Sundry Print Report

Well Name: SAKER 6-7 FEDERAL COM

Sundry ID: 2836622

Type of Action: APD Change

Property Name	Well Number	Drawn By	Revised By
SAKER 6_7 FED	23H	R.J. 12-20-19	REV. 1 Z.T. 10-09-24 (SHL, WELLBORE AND FORMAT CHANGES)

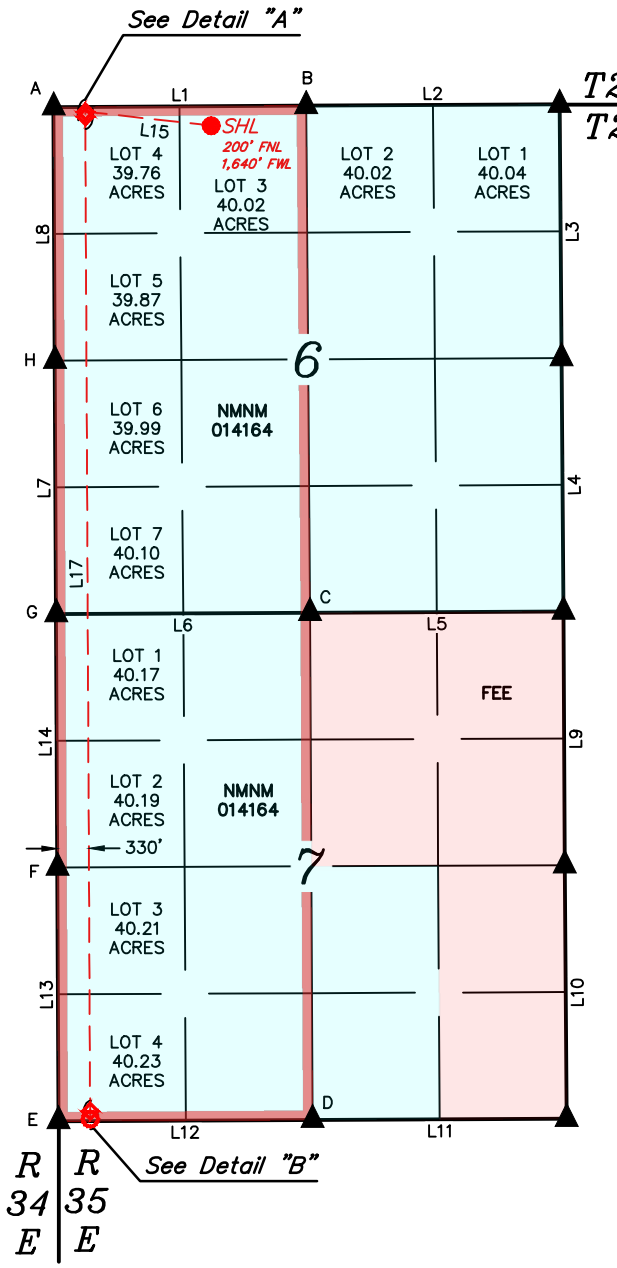
OXY USA INC., respectfully requests to amend the subject AAPD by revising the Well Name, SHL, BHL, TVD & Drill Plan as follows:

Old Well Name: SAKER 6_7 FEDERAL COM 23H
New Well Name: SAKER 6_7 FEDERAL 23H

Old SHL: 200' FNL 715' FWL
New SHL: 200' FNL 1640' FWL

Old BHL: 22' FSL 330' FWL
New BHL: 20' FSL 330' FWL

Old TVD: 10765'

New TVD: 10740'
